CHANGE ORDER FORM

Change Order No: **1**

Project: **PMPL Headquarters Remodel project**

REQUEST FOR PROPOSAL NO. 1

1 Lower Reception
Sheet 1 of 2

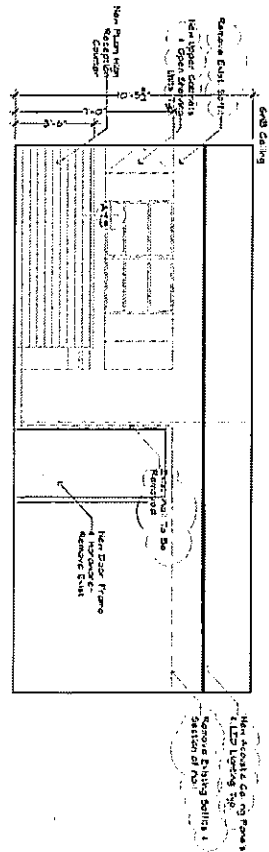
3. Revised location for files and copier (revise outlet locations accordingly). No cost change.
4. Delete adjustable shelving at Reception as shown in 3/A6.0 & 5/A7.3. Provide credit.

2 Upper Reception
Sheet 2 of 2

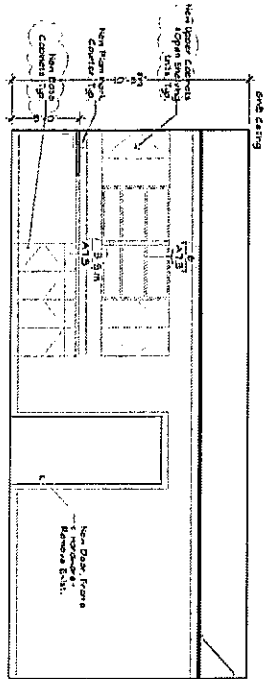
6. Revise Reception and Work Counters layout and dimensions at Upper Reception per attached Sht. A2.1. Provide credit for 34 lf of plastic laminate work counters and 9 lf of low reception counter. Remove non-structural section of wall and soffits above. Provide floor outlets where wall is removed- two outlets at each end of existing wall location.

3 Work Areas @ Upper Floor Reception
Sheet 1 of 2

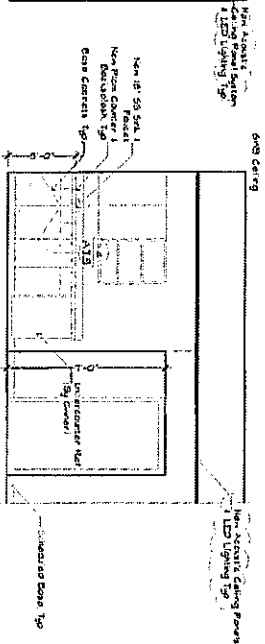
5. Add two upper cabinets at south wall of office area above work counter with two open shelving unit between the cabinets and two base cabinets below.
